# PRODUCT SERVICE NOTICE

PRODUCT/APPL. WANG MATRIX MODEL 77

PCB #210-7131, ECN's #11307 and #11497, E REV 2  
for 2261V and 2261W Matrix Printers

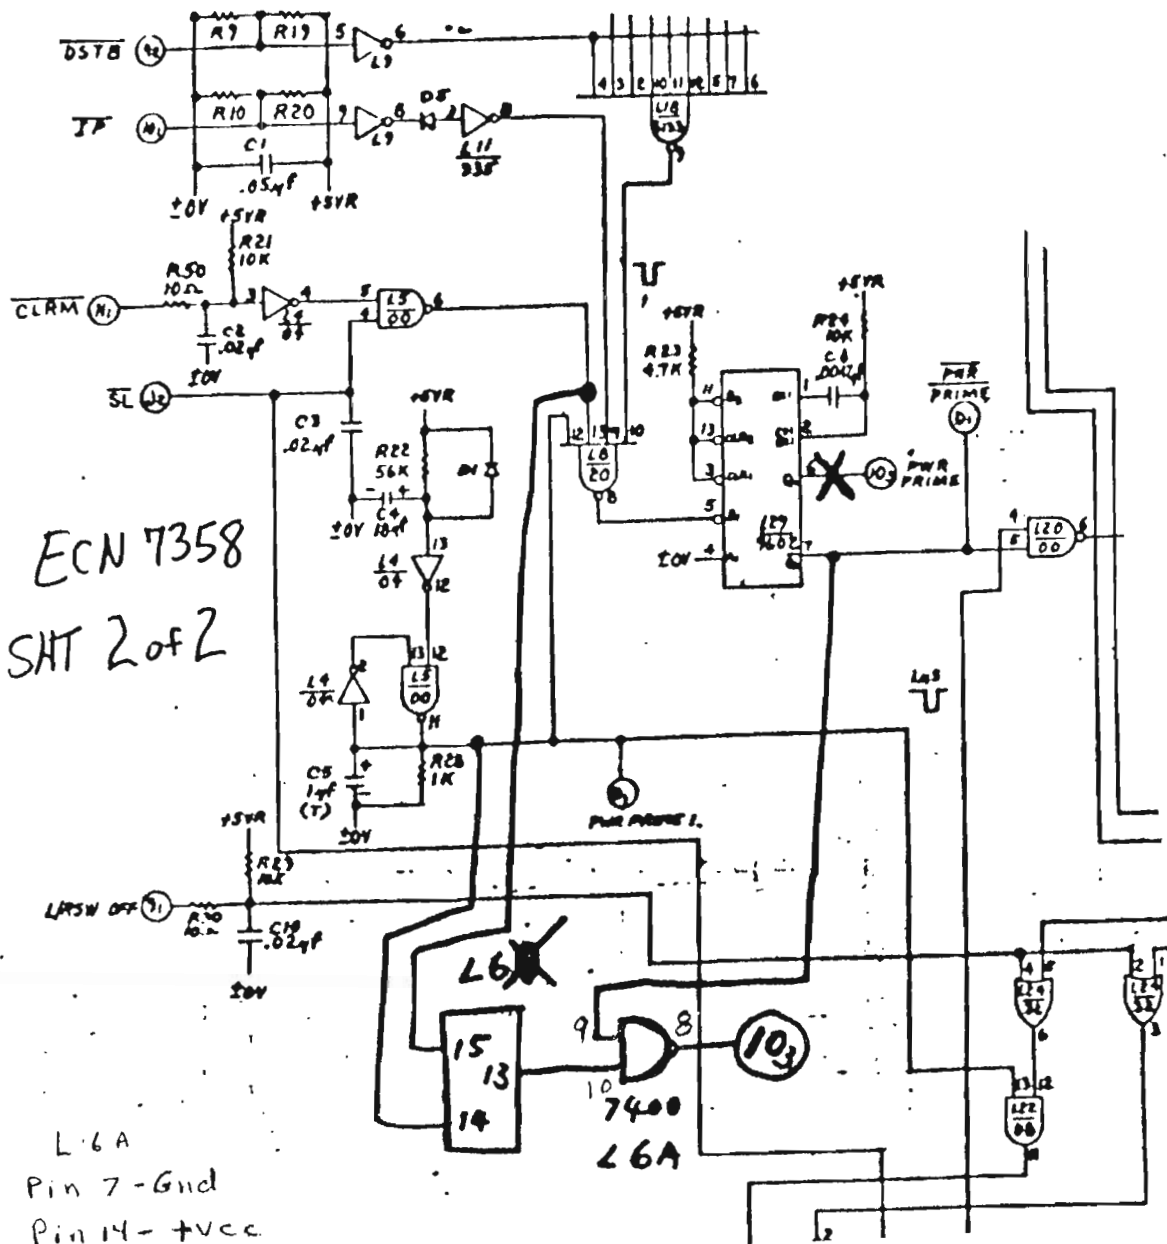
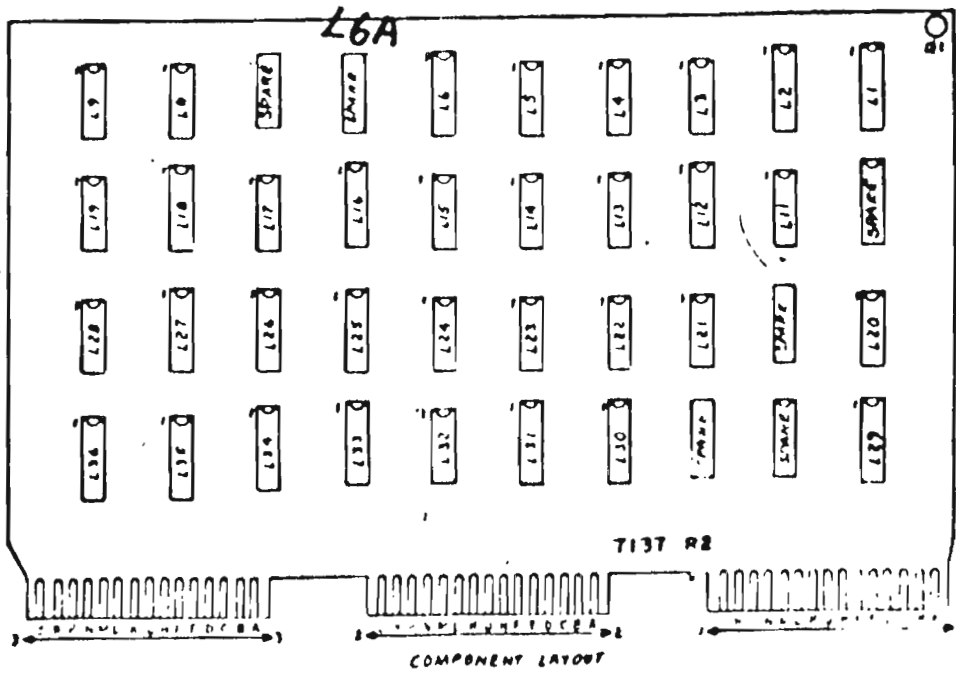
Change artwork, loading sketch and schematic per attached print

To fix bug in the Power On Prime Circuit

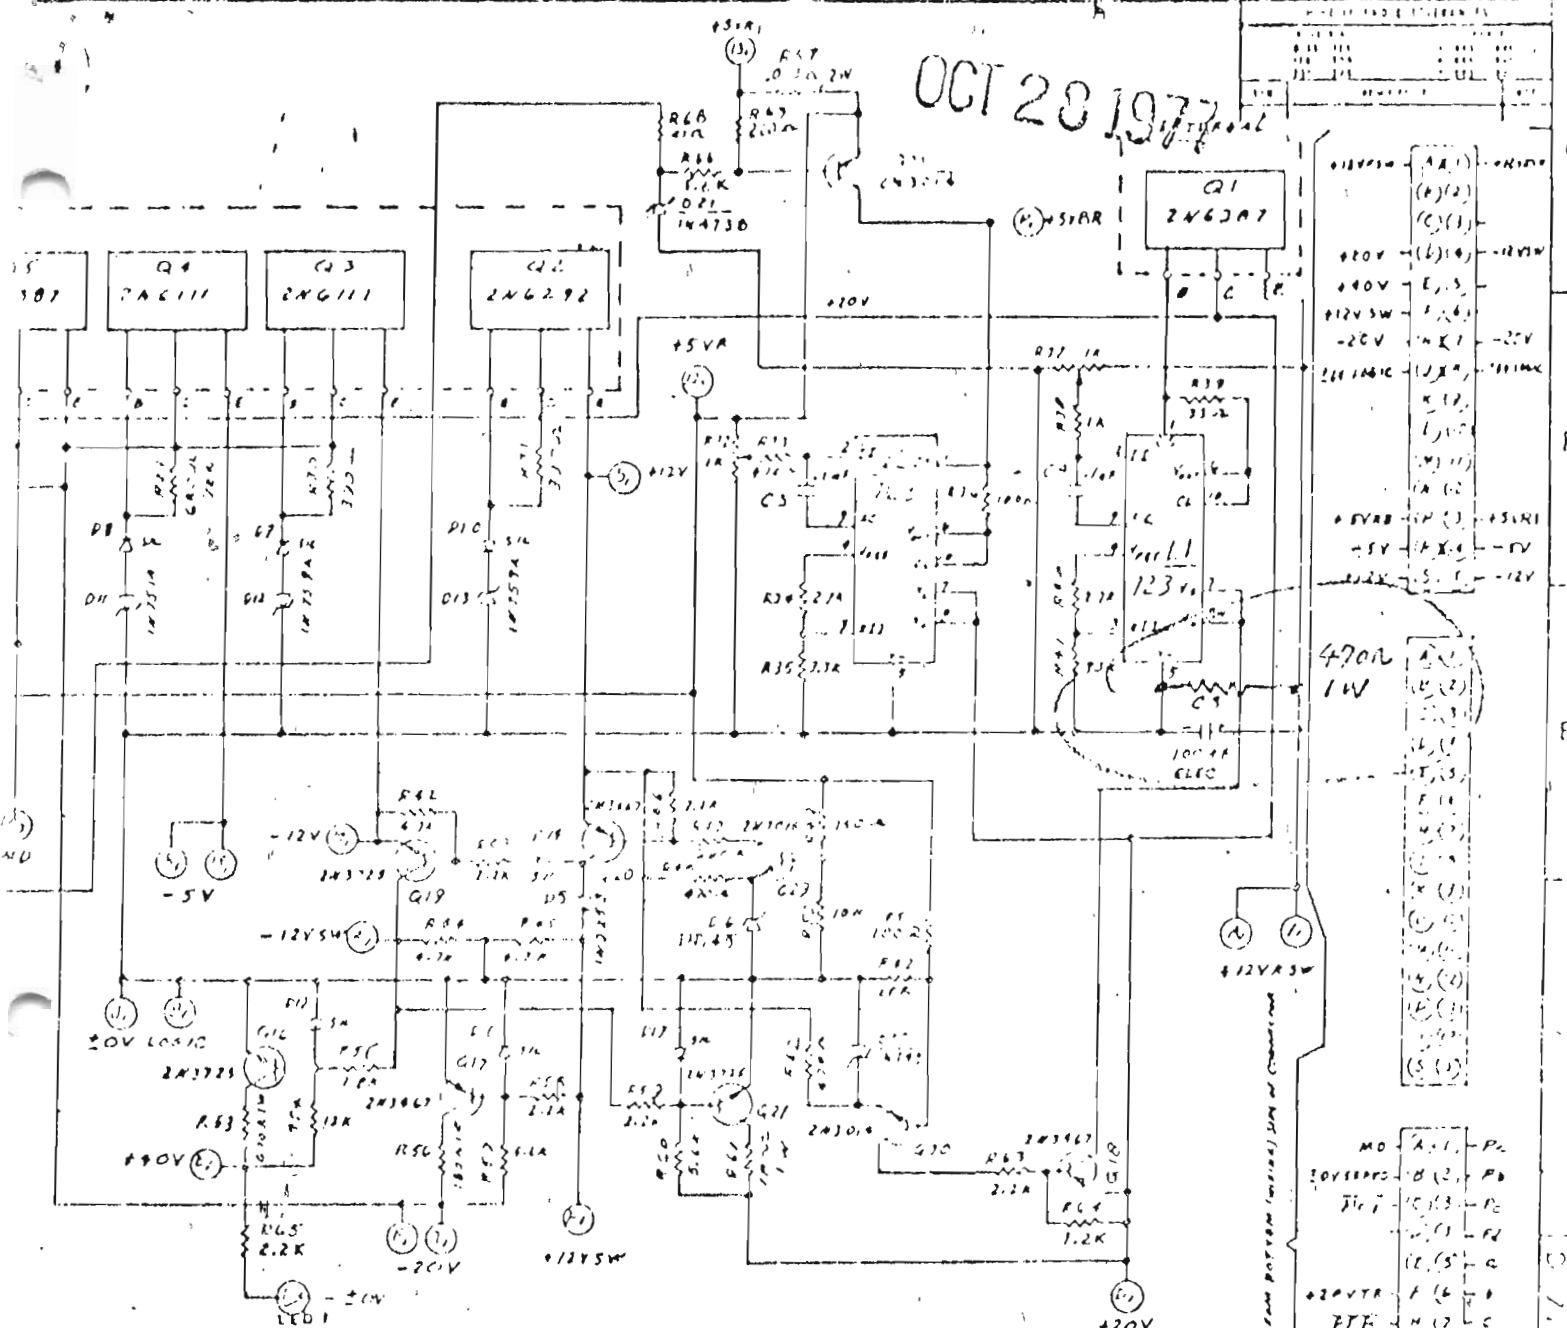
Change artwork, loading sketch and schematic per attached print

To eliminate solenoid misfiring when the power is turned off

WL#	QTY	DESCRIPTION
Add: 332-2047	1	470 Ohm 1W Resistor

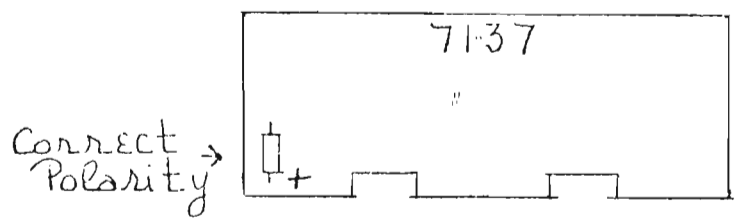
Change sample board as follows:  
 The direction of the 15uf/20V tantalum capacitor on the lefthand component side of the board is reversed. The correct polarity is + towards the fingers (See Below)

To correct polarity  
 320-0030 is an invalid Wang Part Number
